# STATEMENT OF RESPONSE TO AN BORD PLEANÁLA'S CONSULTATION OPINION

PREPARED FOR WESTERN WAY  
DEVELOPMENTS LTD

**IN RESPECT OF A  
PROPOSED SHARED LIVING AND NEIGHBOURHOOD USES  
SCHEME AT THE  
HENDRONS BUILDING AND WIDER SITE, 36-40 DOMINICK  
STREET UPPER, DUBLIN 7**

**DECEMBER 2020**

**Figure 1 - Sketch Model of the proposal showing the active street frontage at Dominick Street Upper**

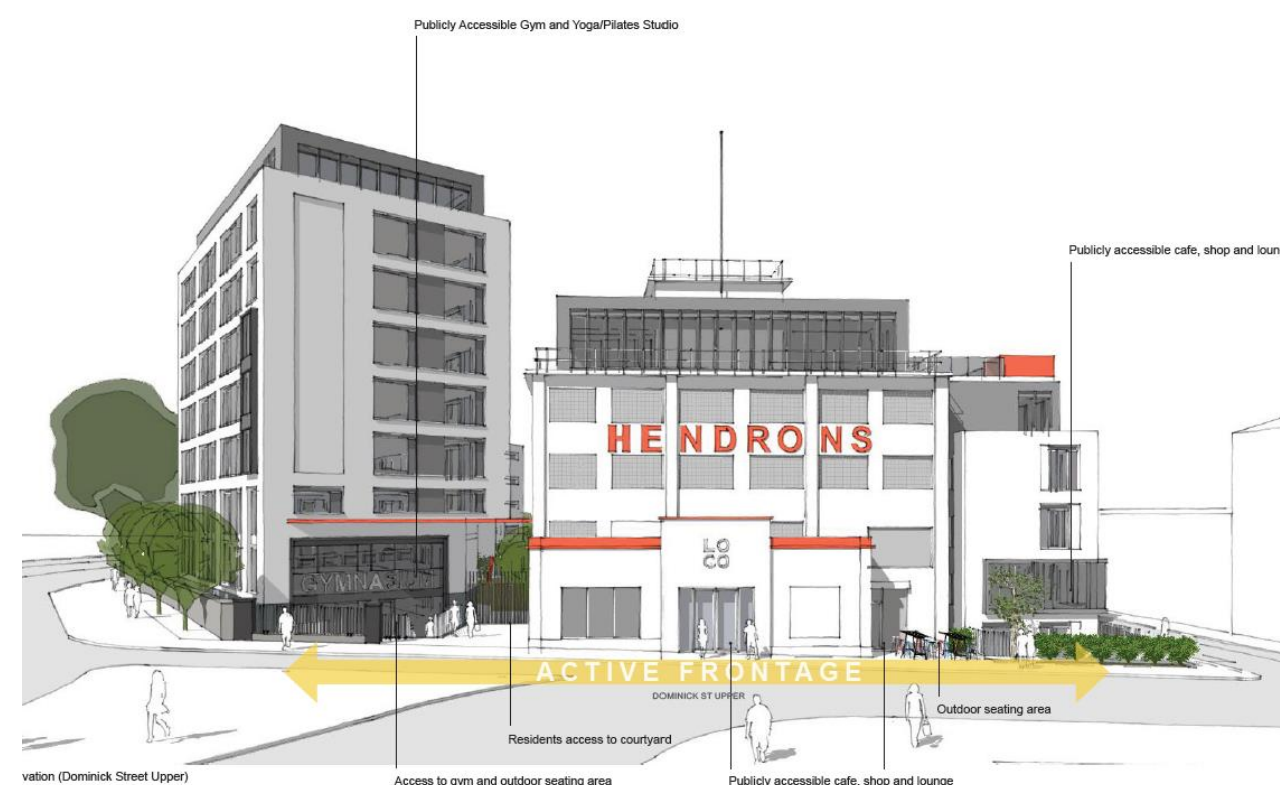
*"Submission of a statement in accordance with Section 5(5)(b) of the Act of 2016 that, in the prospective applicant's opinion, the proposal is consistent with both the relevant objectives of the development, and relevant Ministerial guidelines under section 28 of the Act of 2000. In particular, such statement should demonstrate how the proposed development is in accordance with the Z3 Neighbourhood Centre zoning objective as set out in the Dublin City Development Plan 2016-2022, including detailed breakdown of public uses and how public access to such uses will be managed."*

2.5 The proposed development will contribute to the creation of a sense of place by introducing publicly accessible uses to the ground floor of Blocks A, B (the Hendrons building) and Block C. Community spaces will also be provided at the ground floor of the Hendrons building and within Block A after hours. It is anticipated that these spaces will be utilised by local groups and interest to date has been expressed by the Order of Malta and local artists.

2.6 Outdoor seating is also proposed adjacent to both the gym and café to create an active frontage on Dominick Street Upper with synergies expected to develop between the complementary uses on site.

Figure 4 - Extract from the Architectural Design Statement illustrating proposed finishes

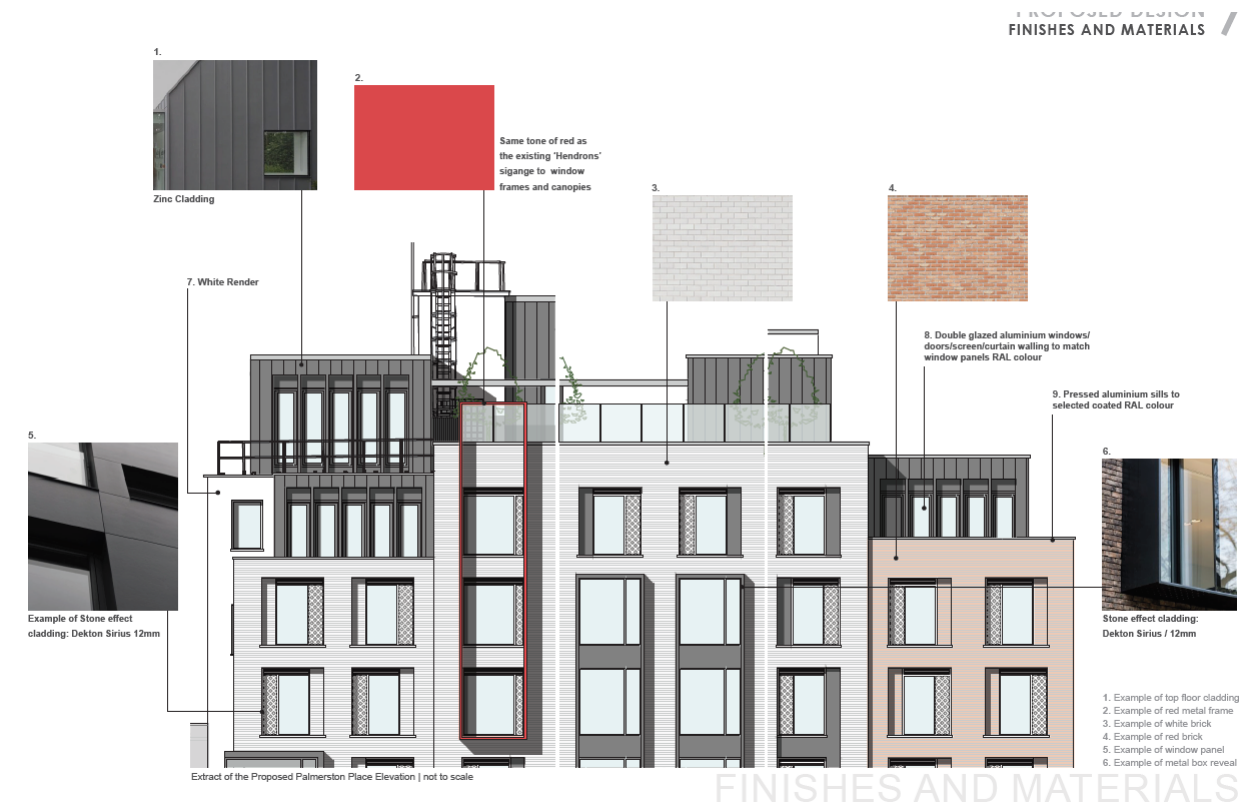
“A report that specifically addresses the proposed materials and finishes having particular regard to the requirement to provide high quality and durable finishes which have regard to the surrounding context of the site and proximity of protected structures.”

### 2.12 Details of the proposed finishes and materials have been addressed within the Architectural Design Statement by John Fleming Architects. The design response is as follows;

*‘The following materials were chosen due to their aesthetic quality, durability and colour. It is our intention that the building will fit harmoniously in the urban scape and that the relationship between these materials will reflect a strategy, visual separation and/or clear contrast between existing and new. Keeping in mind the above goals, the idea is that the majority of the materials respect the selected colour palette: white, dark grey/black and red:*

- *The existing concrete Hendrons building will be restored in white render and the predominant material for the rest of the development will be white brick. We chose brick, because it is the main material in the neighbourhood, and the colour white to keep a ‘memory’ of the demolished house and warehouses.*
- *Selected dark grey aluminium and glazed windows/doors/panels and dark grey cladding to set back top floors along Western Way and Dominick St Upper contrasting the building’s ‘base’ tones.*
- *Red brick with light coloured mortar where the building steps down adjacent to Palmerston Place neighbouring houses to avoid an abrupt visual break with the existing buildings.*
- *Dark grey stone effect cladding panels to window frames;*
- *Feature elements in red throughout the facade inspired by the existing ‘HENDRONS’ lettering and front porch parapet colour’*

Figure 5 - Diagram 2 - Form and Rationale

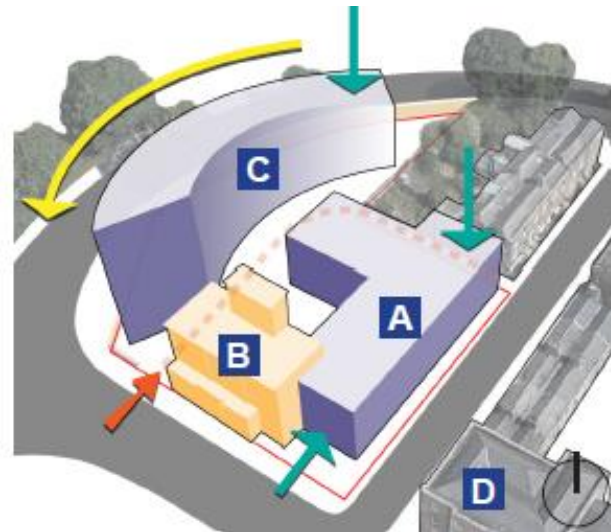
“A detailed design rational for the approach to the massing and height of development on the site, along with additional visualisations / CGS’s illustrating the relationship of the proposed development with Western Way.”

### 2.15 In response, a detailed design rationale and response is included at Section 12 of the Architectural Design Statement provided by John Fleming Architects. This provides details on the design rational for the proposed massing and scale of the development as follows;

*‘the yellow arrows in Diagram 2 represent the three site directions that influenced the proposed building’s footprint. It was decided on this phase of design that the scheme would be composed of three connected blocks: one that would complete the streetscape along Palmerston Place [1], a second one along Dominick Street Upper [2] and a block along Western Way [3] following not only its curving shape, but as well the protect stone wall contour that forms part of the site boundary.’*

*'On the next phase of the design we kept the connection between the new building along Palmerston Place [A] and the Hendrons building [B] but separated the curving building [C] from the rest of the development to accentuate the entrance to the courtyard and expose the existing glass block windows on the northwest facade of the protected building. A lower return wing was added to block A to frame the courtyard. This addition and connection to the Hendrons building was so that the new development would have the same building footprint as the existing house no. 36 and the warehouses to the back.*

*The green arrows pointing down indicate where the lower blocks of the development should be. This is due to their proximity to the three storey houses on Palmerston Place and their gardens. In the majority of its extent the building along Palmerston Place [A] will have the same number of floors as the neighbour building in the opposite corner of Dominick St with Palmerston Place [D].*

*The third green arrow suggests that the new building should setback in the corner to highlight the protected Hendrons building and make it more visible when approaching the site from Dominick Street Upper '*

**Figure 13 - Existing and proposed railings and piers**

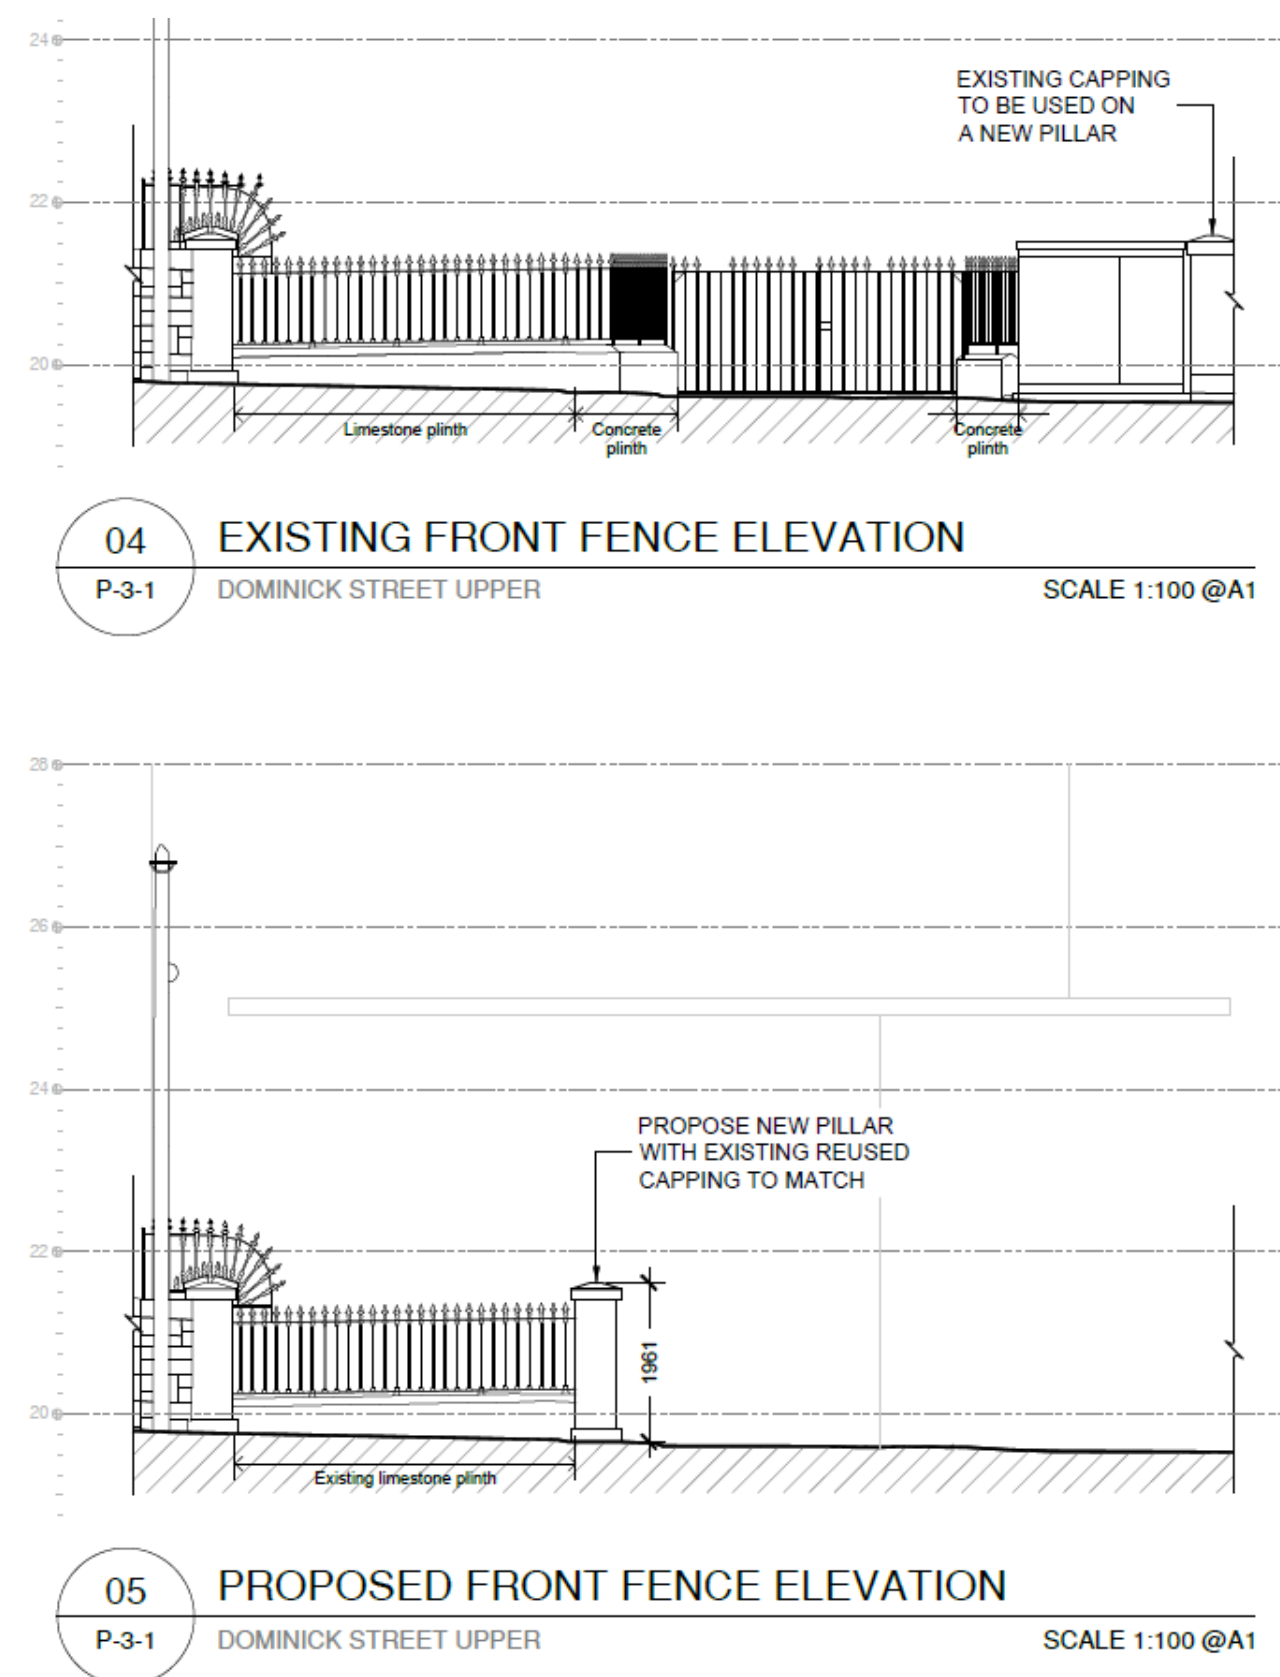
- 6(c) Details shall be provided of proposed refurbishment of the historic railings and entrance piers.

*'a short stretch of nineteenth-century railings survives on the frontage to Dominick Street Upper, close to the junction with Western Way and these were formerly part of the boundary of Palmerston House/Palmerston Terrace. The railings are included in the record of protected structures, the wording being "historic western railings". These railings stop about 600mm from the point where the railings turn towards the entrance to the yard. The junction between the original stone plinth wall and the later concrete plinth wall is directly beneath the point where the later mild steel railing is attached to the earlier wrought iron and a difference may also be seen in the style of the finials and the lack of bosses in the later railings.*

*It is proposed to remove the later railings and plinth wall while retaining and refurbishing the originals. The paint is flaking off the railings and the plinth wall and this will be cleaned back to remove it from the limestone and to prepare the iron railings for repainting. Prior to removal of the paint from the plinth wall test will be carried out on limited areas to determine the optimum method of removal that would not harm the stone beneath. The railings are to be primed with an anti-rust paint suitable for wrought iron and cast iron and repainted.*

*Where the later railings are removed it is proposed to provide a masonry pier to match the existing pier at the end of the railing and which is seen in plate 12 above. The preferred option is to remove the other pier, which is adjacent to the Hendron's building and relocate it to form the termination of the original railings, rather than to erect a new pier.'*

**Figure 16 - Typical section showing underpinning of the boundary wall**

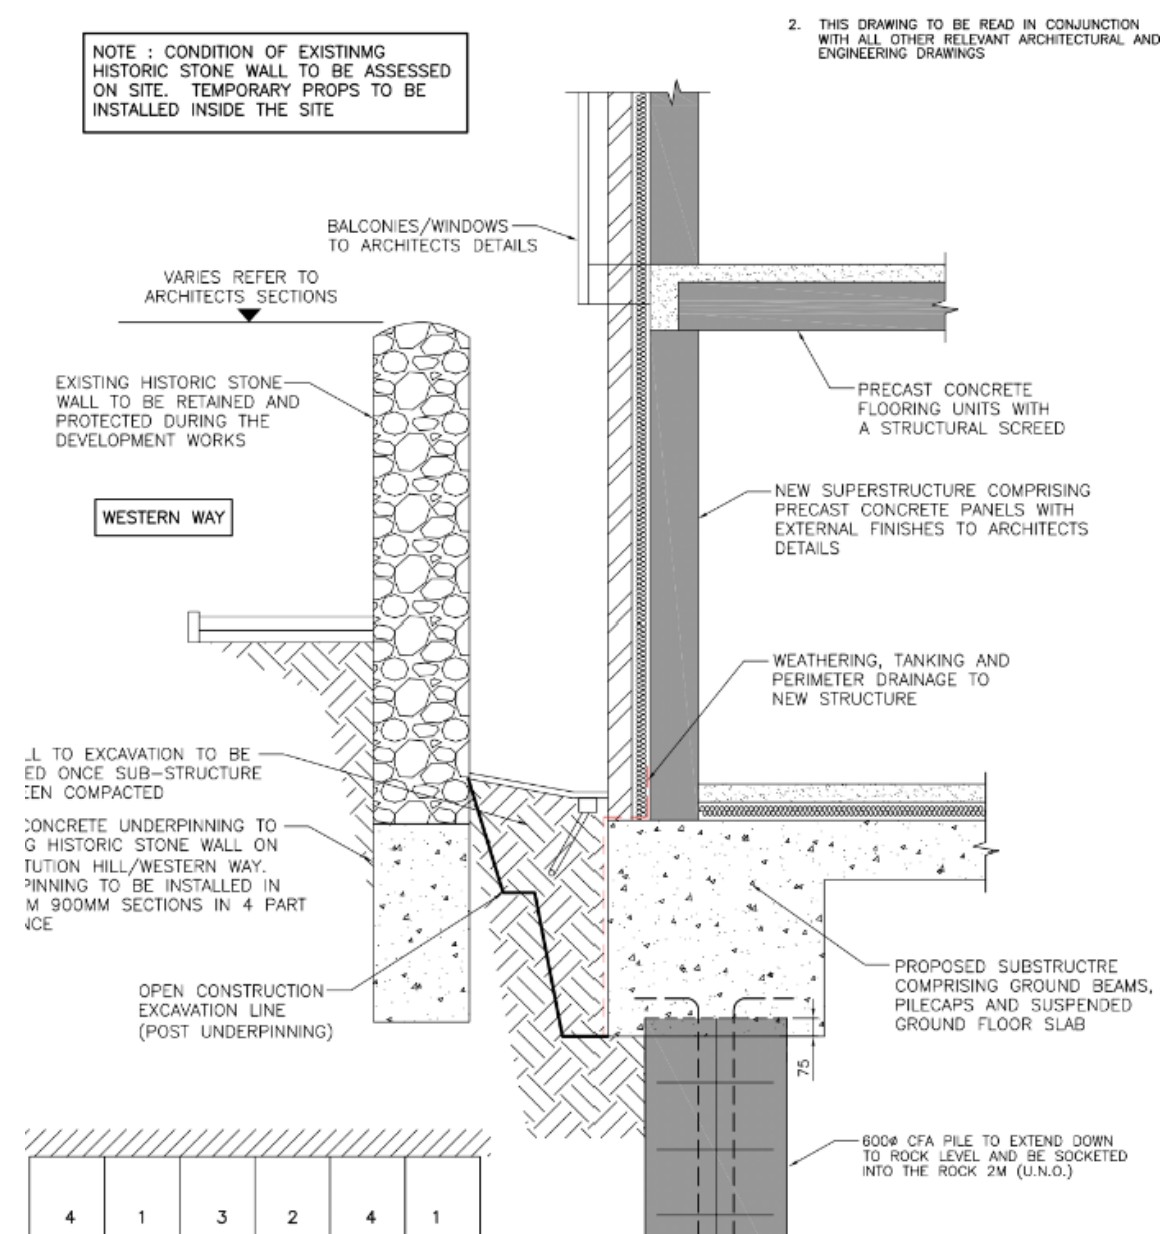
6(f) Detailed sections and structural details shall be provided to illustrate how the new building will be constructed whilst protecting and consolidating the integrity of the boundary wall.

- 2.34 **Response:** We refer to the engineering drawings prepared by Waterman Moylan Consulting Engineers. Drawing no. 310 provides a typical section of the wall in relation to the proposed building adjacent. The methodology proposed demonstrates the retention and protection of the wall during construction.

**Figure 17 - Extract showing proposed gate access treatment to the ESB Substation from Western Way**

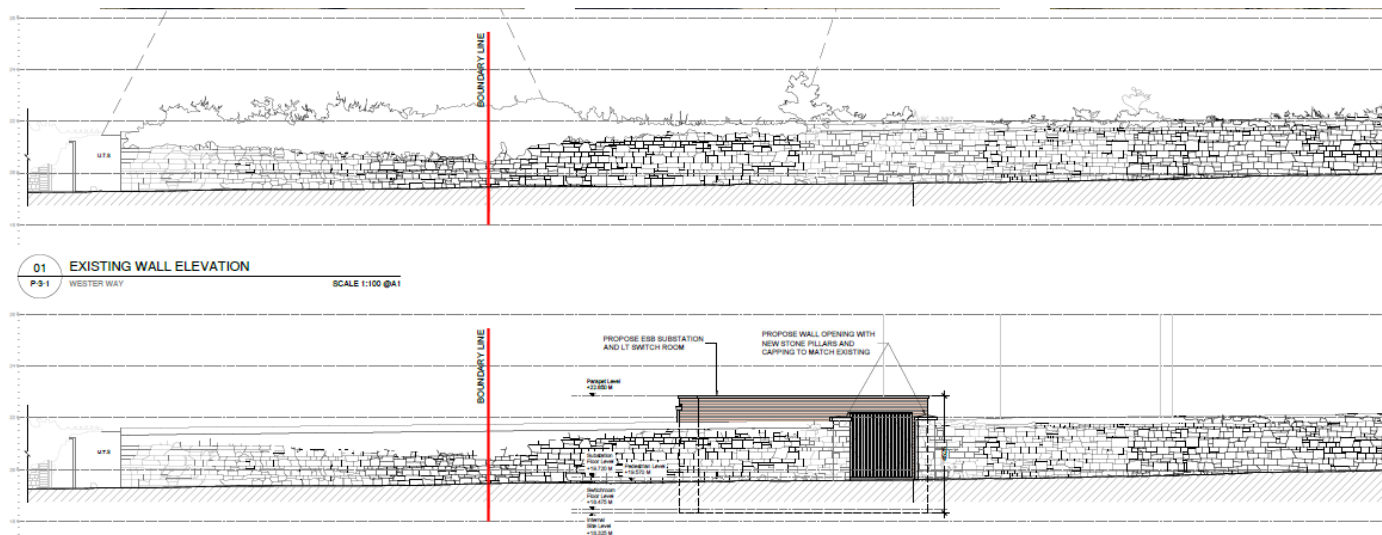
6(g) Details shall be provided of the proposed new access through the wall to the new ESB substation.

- 2.35 **Response:** Access to the proposed ESB substation and switch-room is proposed via Western Way. This will include demolition of a small section of the existing stone wall (c. 2 metres) to facilitate the access point. 24- hour access is required by the ESB to service all substations.

**Figure 18 - Extract showing the treatment of the lightwell adjacent to Palmerston Place**

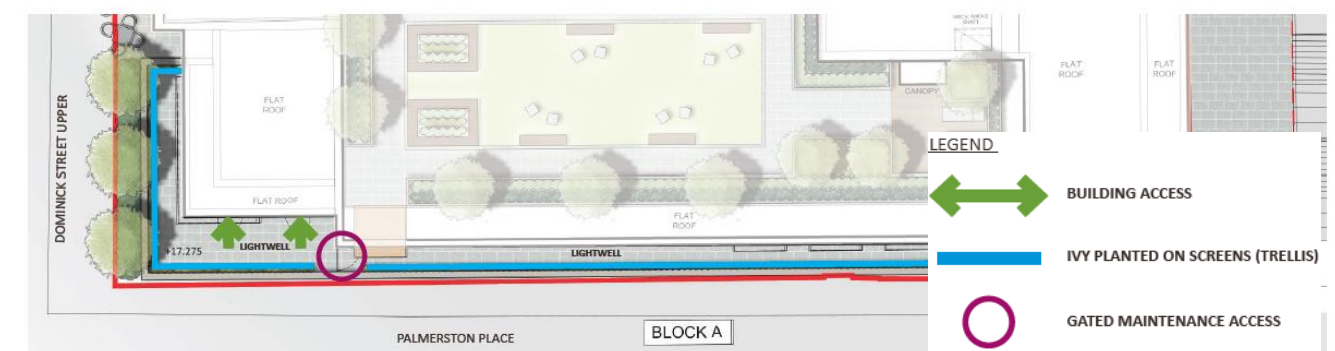
6(h) Details to be provided of the external basement area in front of Block A and how it will be landscaped and accessed for maintenance.

2.39 **Response:** Please refer to the Landscape Masterplan (p27) prepared by Park Hood Landscape Architects. The masterplan states:

*'The landscape design proposes Ivy (Hedera helix) screens to be planted along the wall of the light well in front of Block A. The Ivy will provide year round colour and upright coverage along the wall. Paving in the light well area is proposed to be a similar material to the courtyard.*

*The light well can be accessed by the residents through the LKD on the lower ground floor level. Residents will have access to the light well on the corner of Dominick Street Upper and Palmerston Place.*

*Gated access within the lightwell along Palmerston Place provides access for maintenance/operations. This area will not be accessed by residents. '*

**Figure 19 - Extract from P-2-2 prepared by John Fleming Architects**

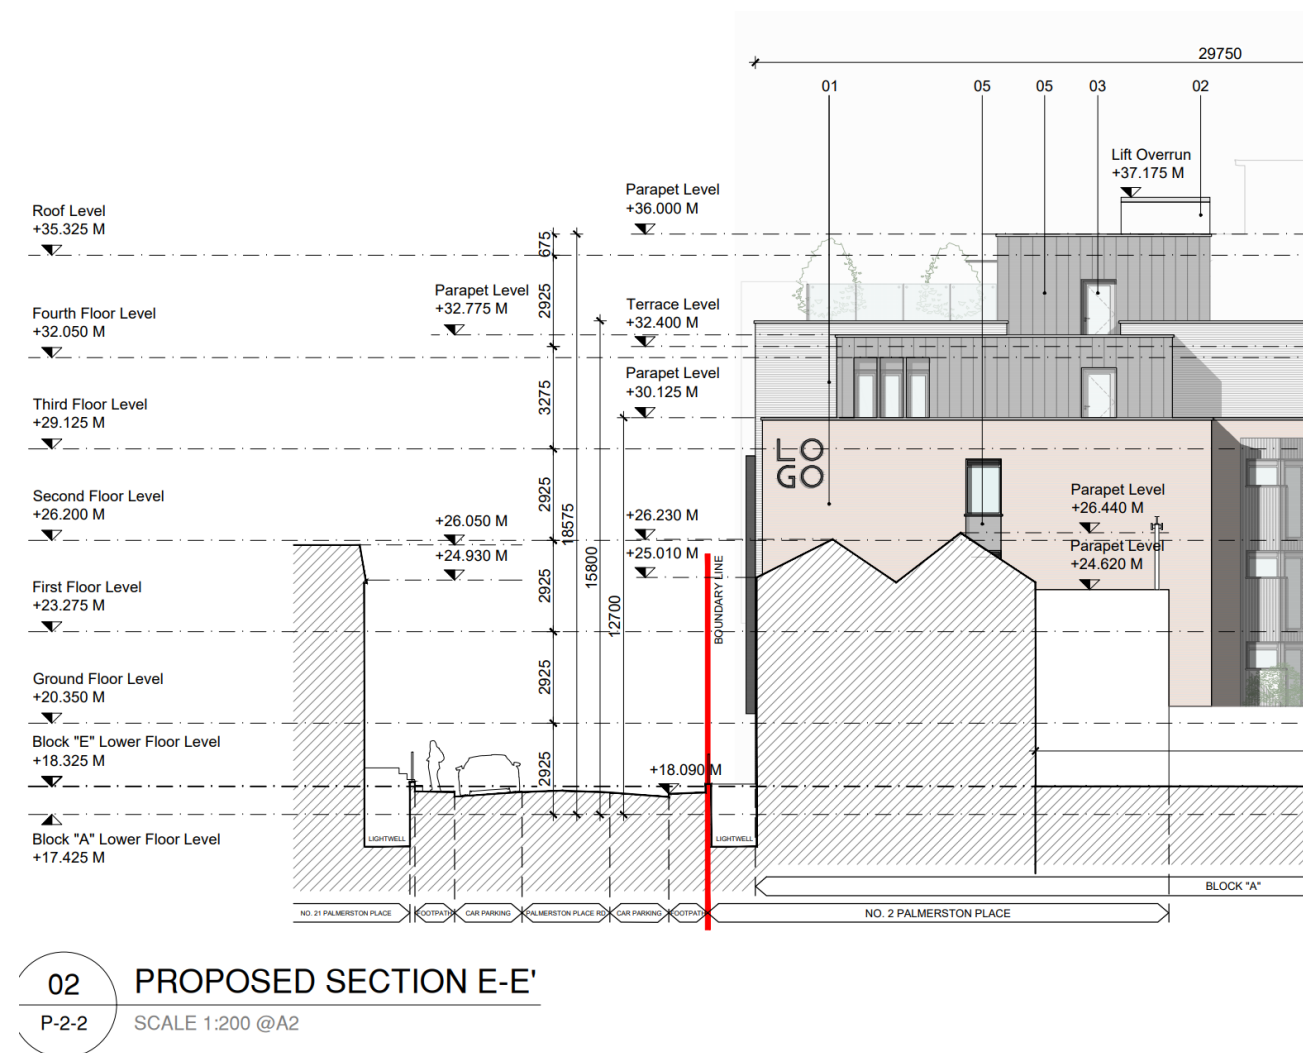
6(i) Parapet heights indicated on all existing terraced brick houses indicated on section drawings for comparative purposes.

2.40 **Response:** We refer to John Fleming Architects drawing numbers P-2-2 and P-2-1 with extract below showing parapet heights as required.
